Re. Your letter dated April 18, 1999 regarding CGRI's Evaluation of the Tylon Fuel Saver Technology.

ETV CONFIDENTIAL REPORT ON FUEL PREHEATING INVENTION

Tylon Fuel Saver (Fumace Cycle 2)

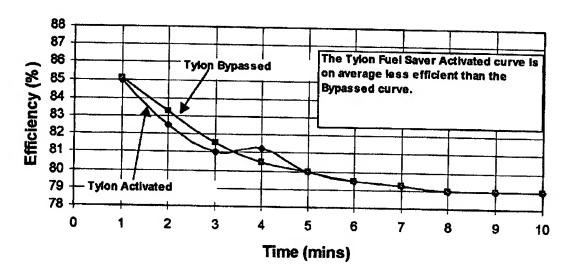
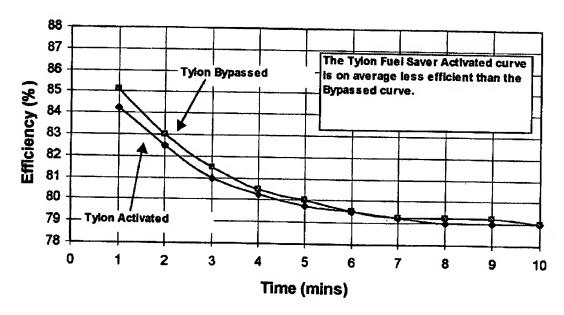
These overall efficiency figures were calculated using the "flue loss method". This method determines the sensible and latent energy lost in the combustion products going up the flue. The figures are determined by temperature differences between what goes in and what comes out and also from the flue Carbon Dioxide concentration, which gives an indication of the excess air level in the flue.

The Efficiency determined using this method includes both the energy output in the load air and the energy lost from the furnace to its surroundings.

The energy lost from the furnace to its surroundings (casing or jacket losses) was not measured, however they are generally not very high and for a furnace would contribute to the heating of a house. It is CGRI's opinion that the casing losses would not have changed significantly when the Tylon Fuel Saver was activated as compared to its being bypassed, during the ITS testing.

There was a net decrease in the energy supplied to the furnace and an increase (or no change) in the energy being lost up the flue, so unless there was a significant change in the casing losses (which cannot be determined) there is no explanation for the dramatic increase in energy output in the load air being claimed.
